ZONING PERMIT # 0804-11801

SITE PLAN FOR:
JOHN PETRO

SCALE: 1" = 20'	APPROVED	DRAWN BY: SWC
DATE: AUG. 04		REVISED
BEING SUBLOT 13 IN THE HERMITAGE BLUFFS SUB AS RECORDED IN VOLUME 42 PAGE 12-1 IN THE LAKE COUNTY RECORD OF PLATS TOWNSHIP OF CONCORD - COUNTY OF LAKE - STATE OF OHIO		
JOB# 04-4022		DRAWING NUMBER 04-2500

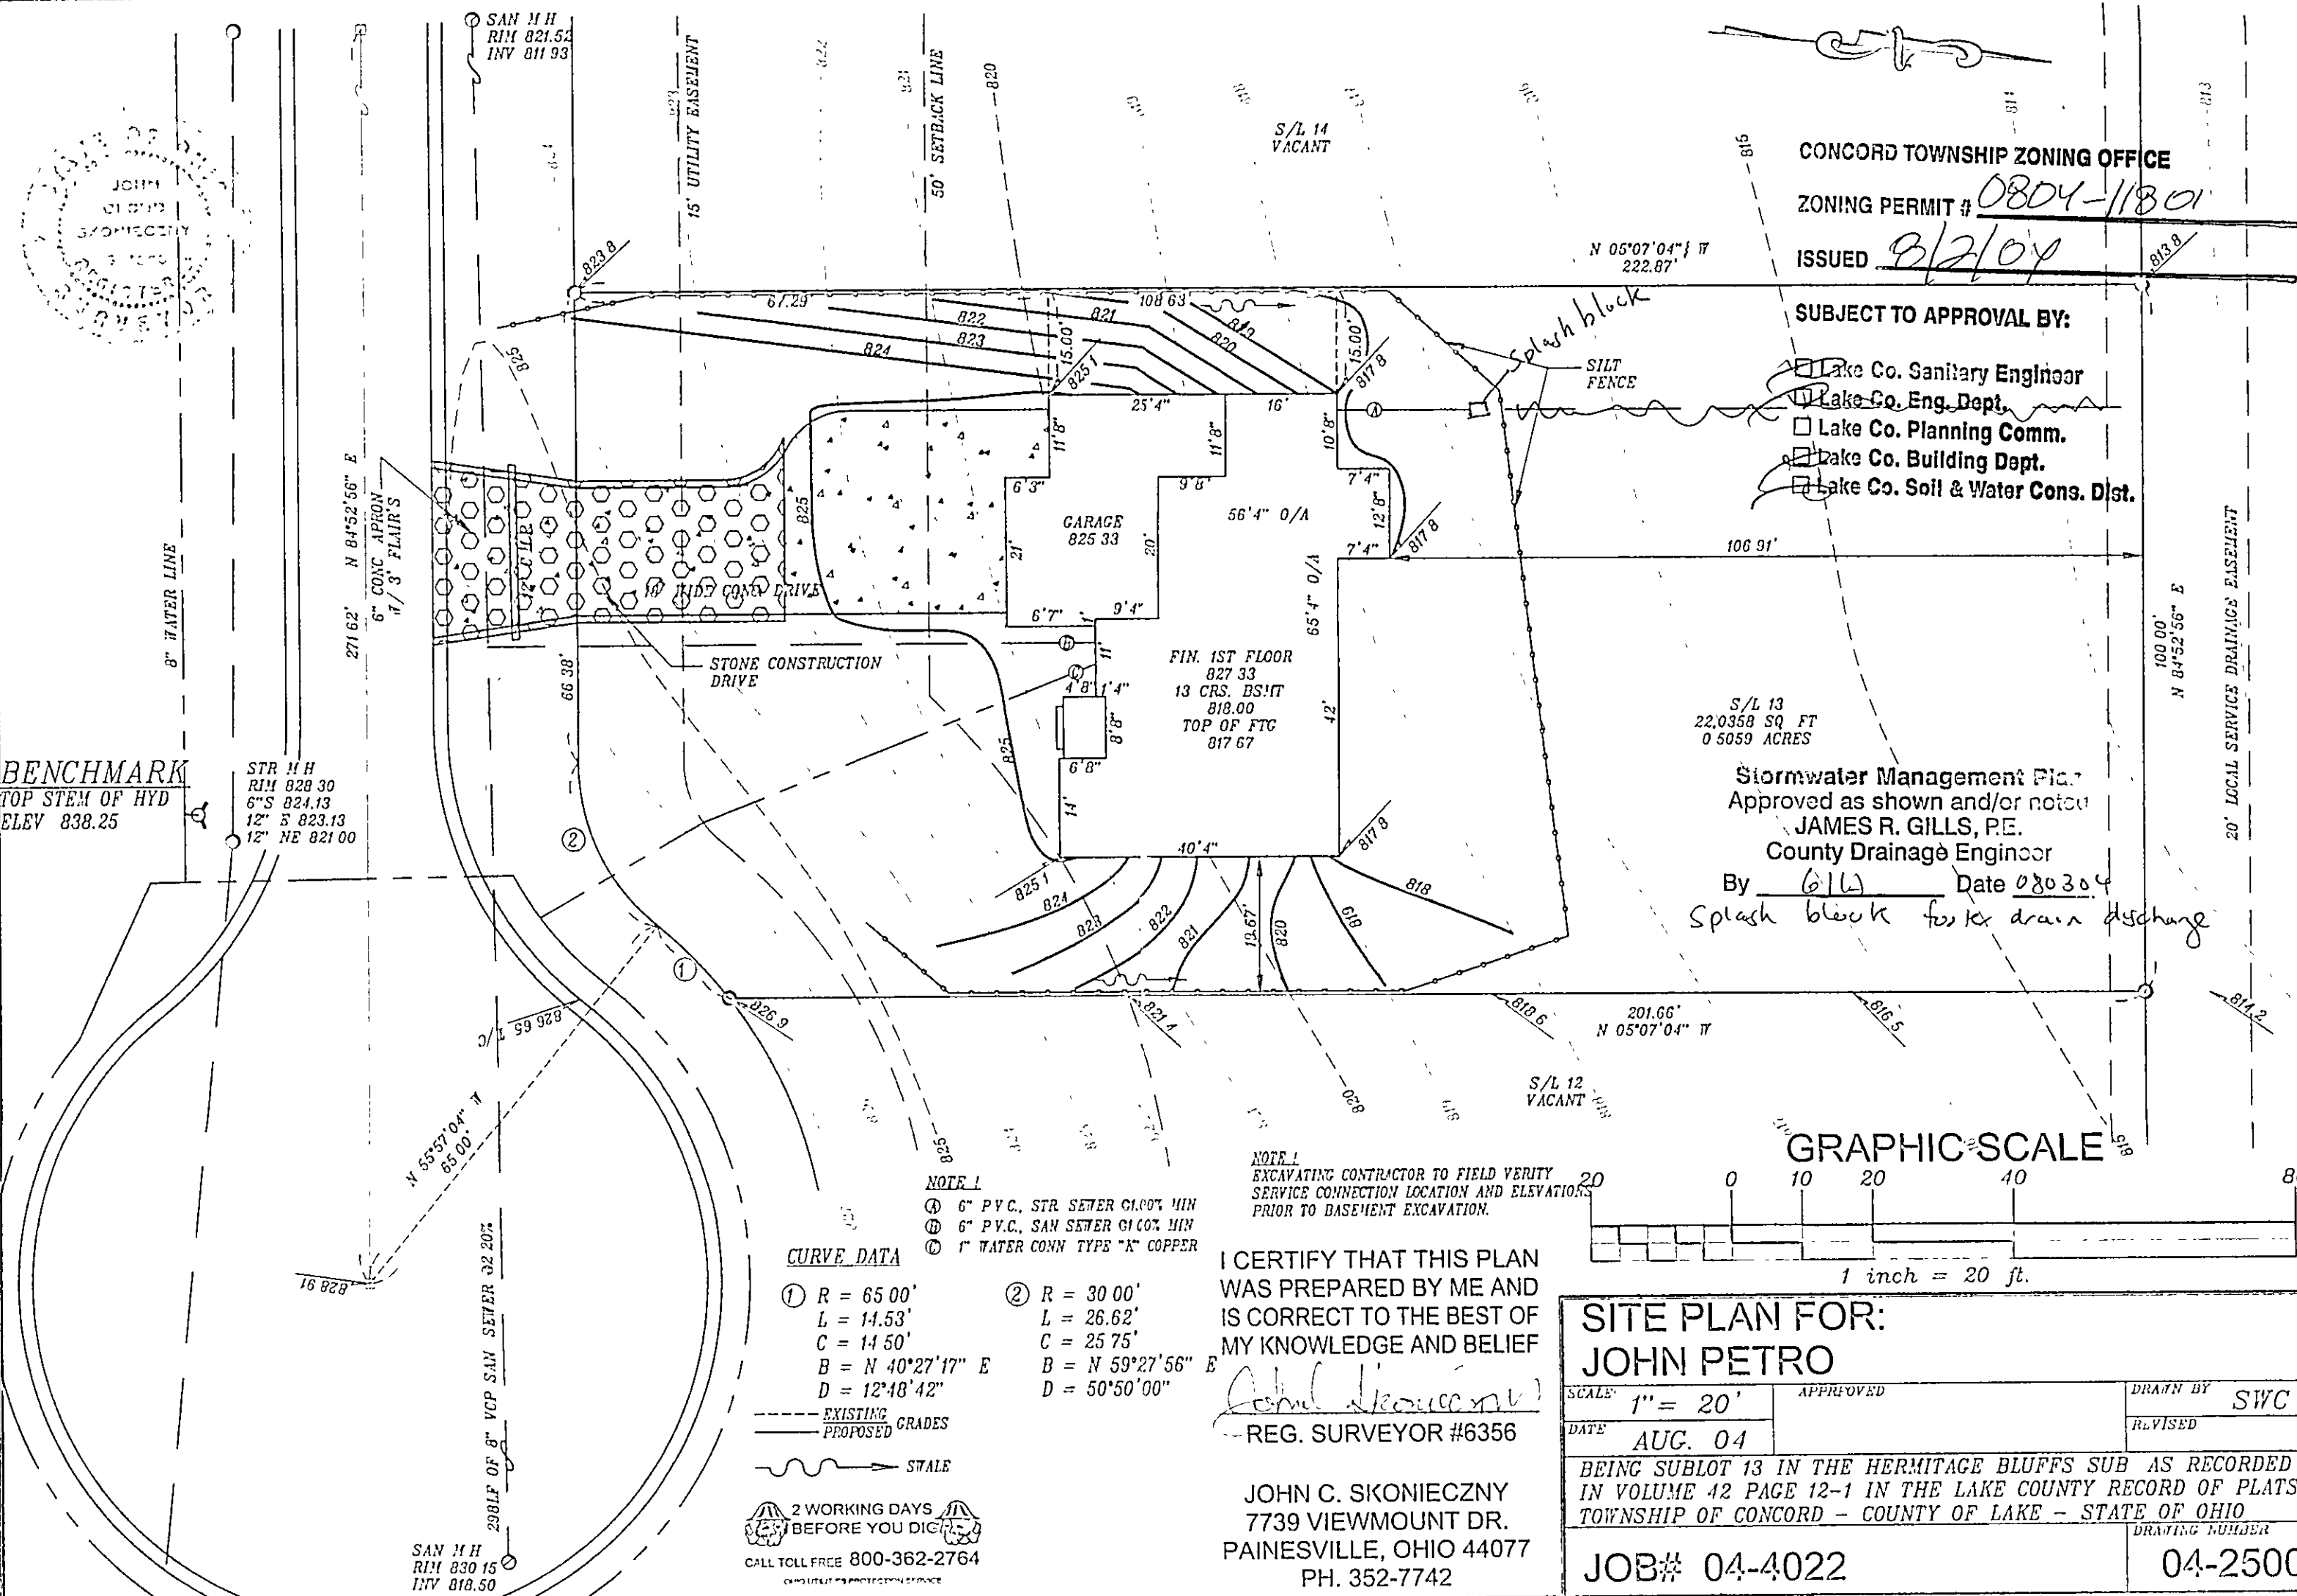
Splash block for drain discharge

Stormwater Management Plan
Approved as shown and/or noted
JAMES R. GILLS, P.E.
County Drainage Engineer
By GL Date 080304
